Determination 2009/43

Determination regarding the code compliance of chimney flashings on a house at 119 Derwent Crescent, Invercargill

Figure 2: The apron flashing details

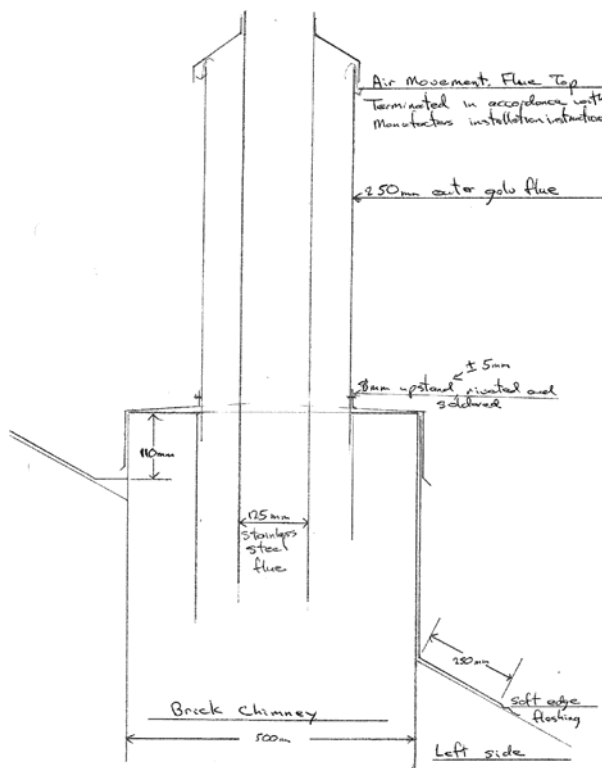
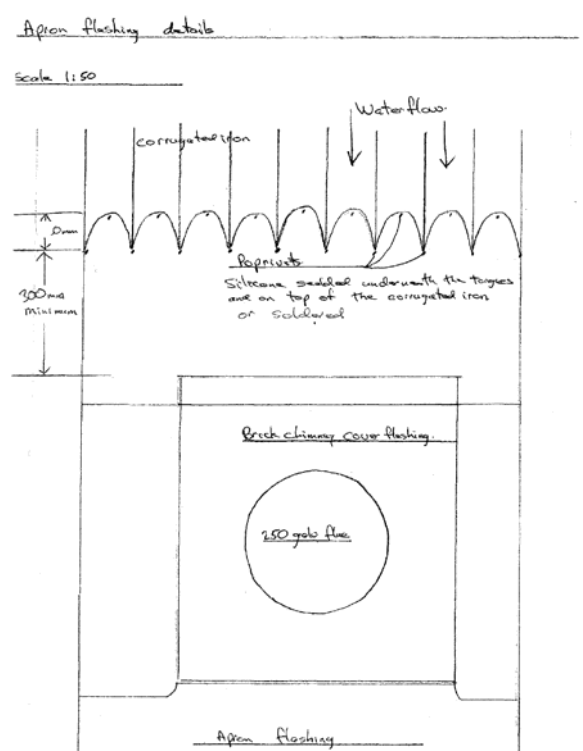
- 7.2 The authority's concern is that the gutter flashing behind the chimney is not detailed in accordance with Figure 55 of E2/AS1 and in the initial proposal relied on silicone to seal the junction with the roofing. The plumber maintains that the detail provided, using silicone and pop rivets, is an alternative solution that is as effective as that shown in Figure 55.

- 7.3 I have closely examined the detail forwarded by the plumber and contrasted it to the acceptable solution in Figure 55 above and have considered the plumber's comments in response to the draft. I concur with the authority's concern that the initial proposal using silicone would be reliant on sealant for compliance with Clause E2. While the flashing may not leak initially, it is at risk of leaking within the expected life of the roofing. Therefore, I am satisfied that that the chimney flashing as detailed in the initial proposal using silicone would not comply with Clause B2 of the Building Code.

- 7.5 I would be prepared to accept that provided the flashing is pop-riveted and soldered to the roofing, and that a fall equivalent to that indicated by Figure 55 is provided in the length of the gutter flashing so that water cannot pond at the joint, that this detail could comply with Clauses E2 and B2. I note the proposed detail would be dependent on a high standard of workmanship and that the authority, in its final inspection, would need to be satisfied on reasonable grounds as to the standard of workmanship when issuing the code compliance certificate.

7.6 I acknowledge the comments made by the plumber (refer paragraph 3.7) that the use of an EPDM boot described in E2/AS1 is also reliant on sealant to achieve a weathertight joint. However, an EPDM boot is easily moulded to a roofing profile and has provision for the sealant to be applied between two parallel mating surfaces. In this instance the sealant joint would be applied between the surface of the roof and the tapering edge of the flashing.

8.1 I would suggest that the applicant provides a revised flashing/gutter detail to the authority showing the use of pop rivets and solder to seal the tongues of the flashing to the roof. The authority can then issue an amendment to the building consent and, if the final inspection satisfies the authority, a code compliance certificate may be issued.

9.1 In accordance with section 188 of the Building Act 2004, I hereby determine that the proposed roof flashing, if pop-riveted and soldered to the roofing as detailed in paragraph 7.5, would comply with Clauses E2 and B2 of the Building Code
